REMARKS

Amendments to the Drawings:

FIG. 2

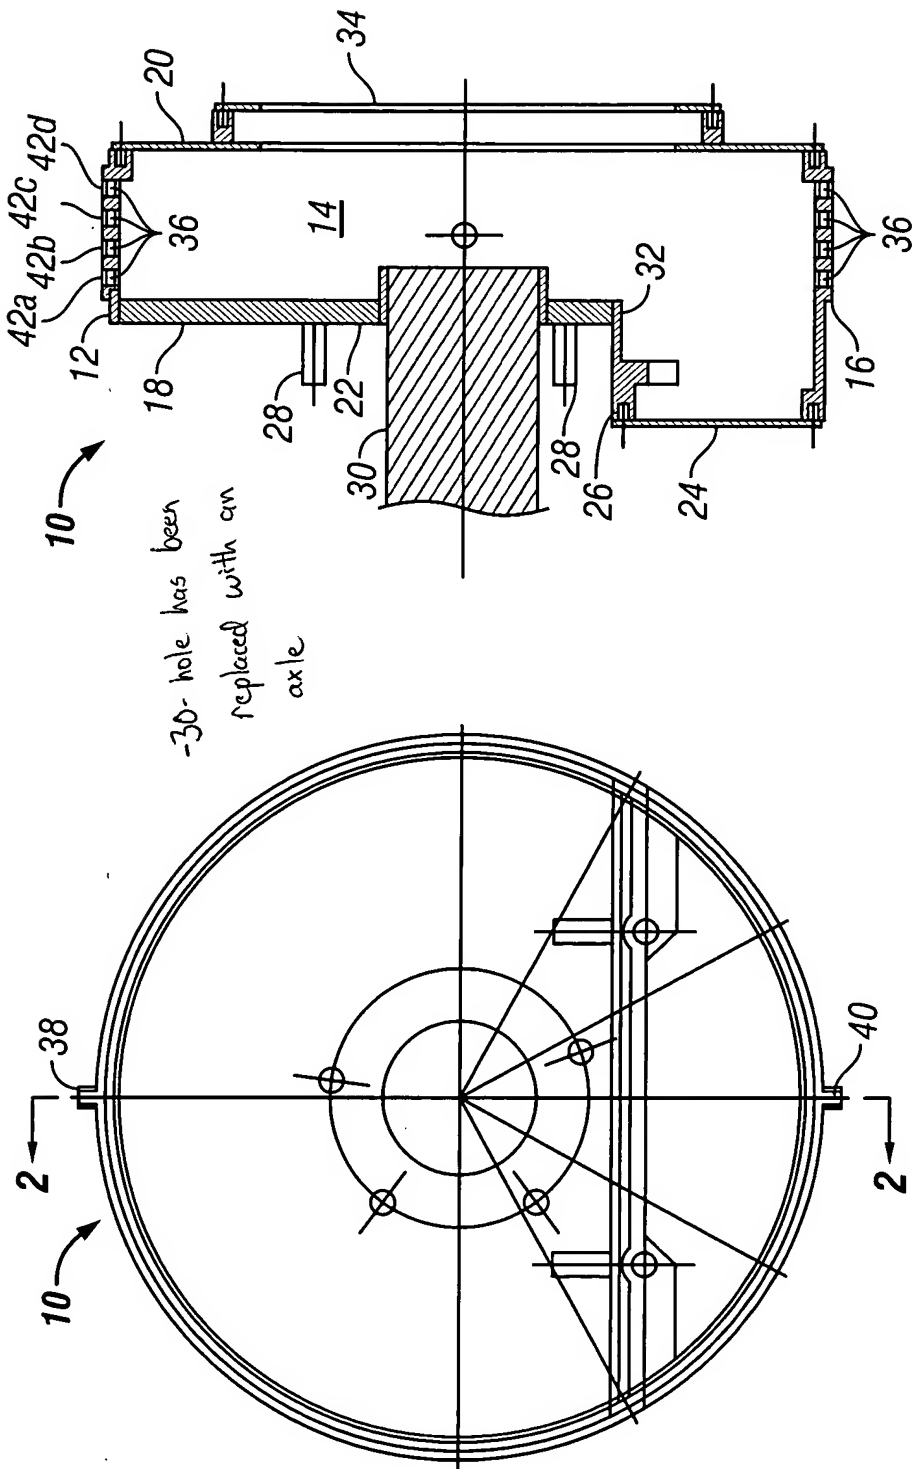
The drawings have been amended to comply with the Examiner's objections. Figure 2 has been amended to show the axle recited in claim 4. The objection concerning element 49 of figure 5 has been addressed by submitted an amended drawing with a correct numeral 52 as described in the specification. The objection concerning element 44 has been addressed by amending the specification to refer to elements 44a and 44b rather than an element 44. The objection concerning element 52 not being shown in the drawing has been addressed by correctly renumbering element 49 of figure 5 as element 52. The objection concerning element 64 not being shown has been addressed by adding a numeral 64 in figure 6 identifying a sealing means previously shown in the drawings. The amended drawings are believed to be in compliance with 37 CFR §1.121(d).

The attached sheet of drawings includes changes to Figures 2, 5, and 6. In Figure 2, previously omitted axle (identified as -30-) is added. Due to the change in the drawing, the “hole”, previously identified as -30- is no longer shown. The specification has been duly updated to reflect the change. The addition is supported in the previously filed specification. In Figure 5, -49- is changed to -52-. In Figure 6, element -64- has been identified.

FIG. 5

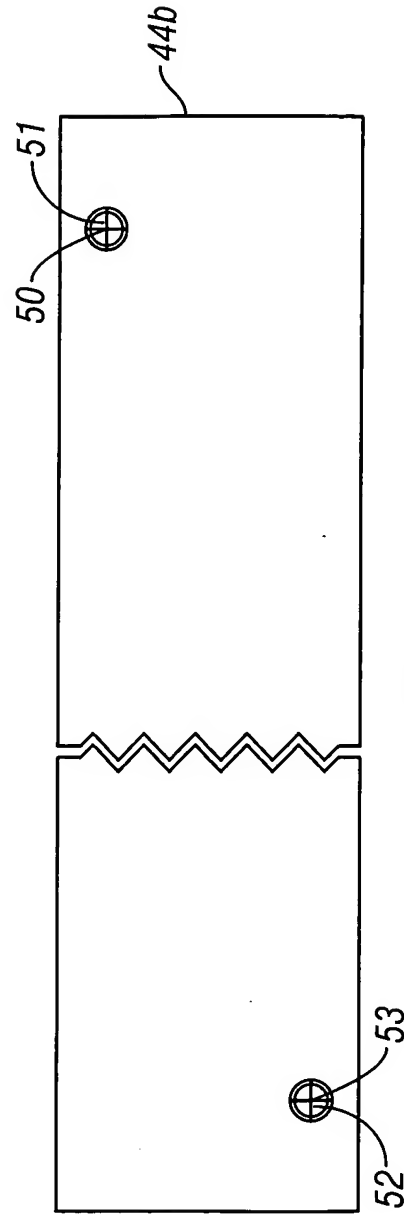
changed from -49- to -52-

FIG. 6

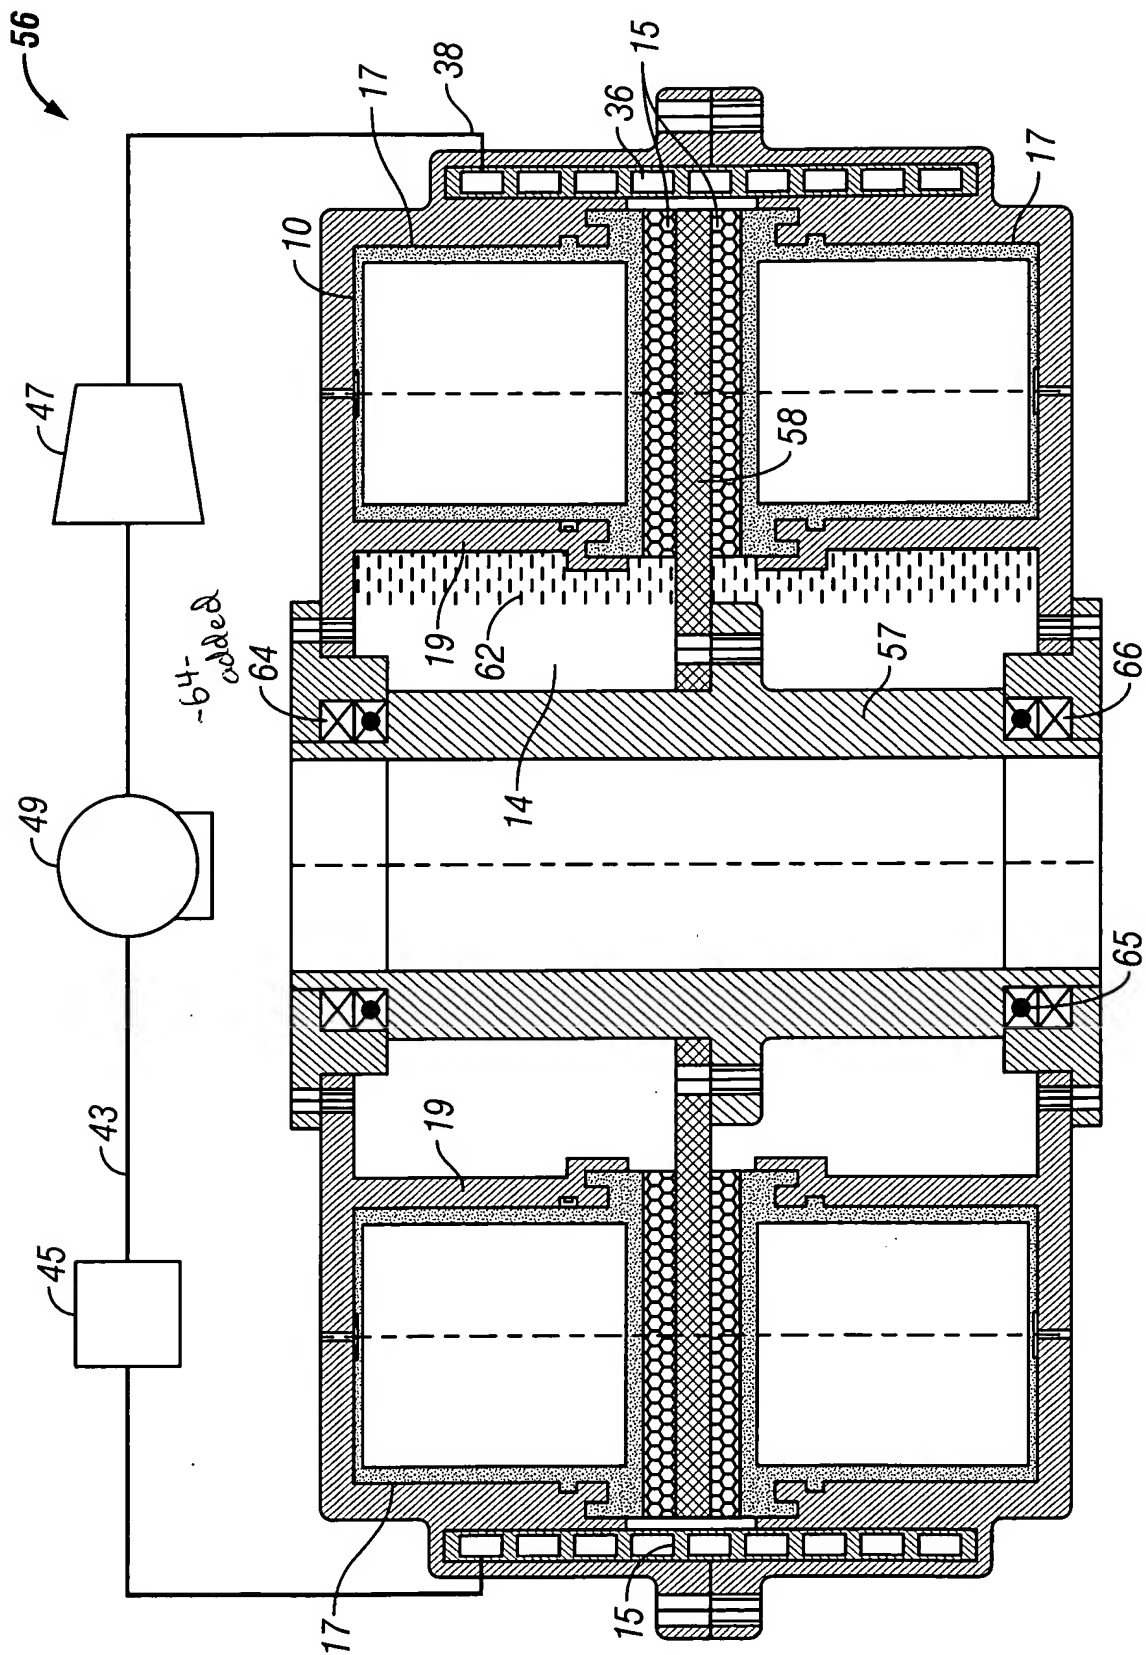
The sealing means shown in Emmons is not the same type of sealing means of the present invention. In fact, the sealing means of the present invention has a completely different use and function. Figure 6 shows an exemplar of the present invention. The sealing means 64 and 66 prevent the loss of fluid 62 contained in the cavity 14 from escaping from the interior of the housing 10 to the outside environment. In Emmons, the Examiner points to element 65, a sleeve, in figures 6 and 7 as a “sealing means.” Emmons states:

The sleeve in the Emmons reference is intended to seal between the piston and the cylinder 53 as shown in Figures 3, 6, and 7. It does not “seal[] the cavity when the housing is mounted on an axle” In the present invention, the sleeve of Emmons would be analogous to a component between the piston 17 and the cylinder 19, shown in Figure 6 of the present invention, designed to assist in the actuation of the piston, not sealing the housing and the wheel hub 57 to prevent leakage of the fluid 62. The sealing means in Figure 6 are shown by rotary seals 64 and 66.
